UNITED STATES PATENT AND TRADEMARK OFFICE

10/542,172

| Office Action Summary | Application No. 10/542,172 | Applicant(s) CORBEAN ET AL. | |

Election/Restrictions

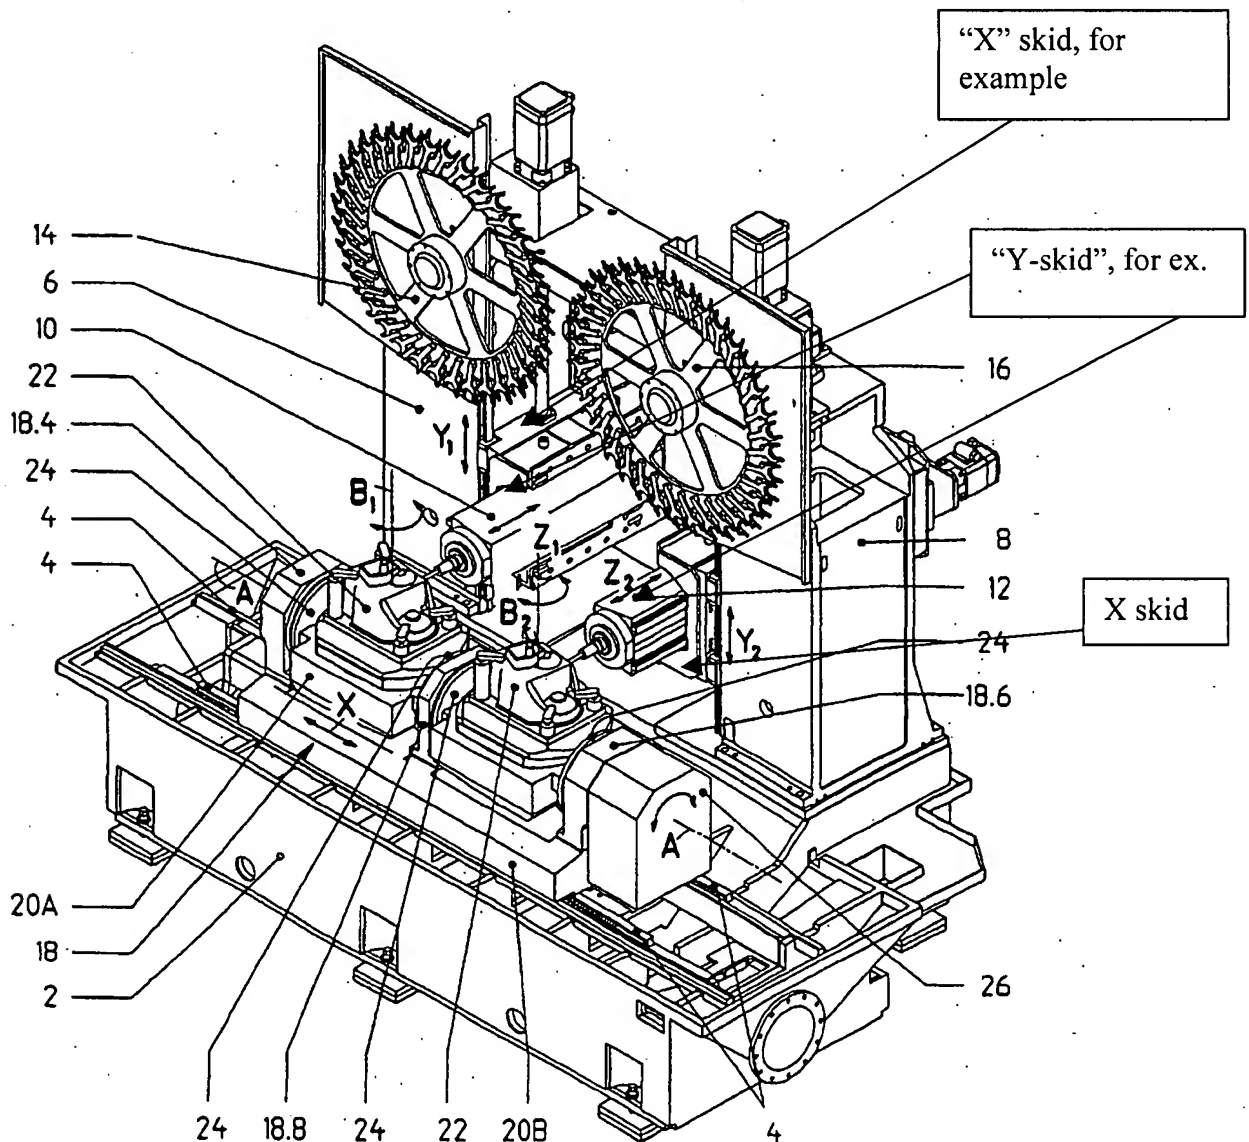
claims, i.e., the features of independent claim 1, do not constitute "special technical features" since they do not make a "contribution" over the prior art in light of at least DE 20118456 (hereinafter, DE '456), for example.

Specifically note that DE '456 teaches a "double spindle machine tool" (see Figure 2) including a "frame-type stand" 2 (for example), at least one "x skid" (labeled below) movable in a direction that can be considered the general "x direction" as claimed, labeled by DE '456 in Figure 2 as "Y".

Additionally, DE '456 teaches at least one "y skid" (labeled above) movable in a direction that can be considered the general "y direction" as claimed, labeled by DE '456 in Figure 2 as "Z".

Note that the tool spindles are mounted to the labeled "Y" skids, and are non-displaceable in a third direction, labeled above as "X", considered the "Z" direction as claimed.

Also noted that "skid" 18 has two work carriers mounted thereon (see Figure 2) and is movable in the direction labeled as "X", considered the claimed "Z" direction.
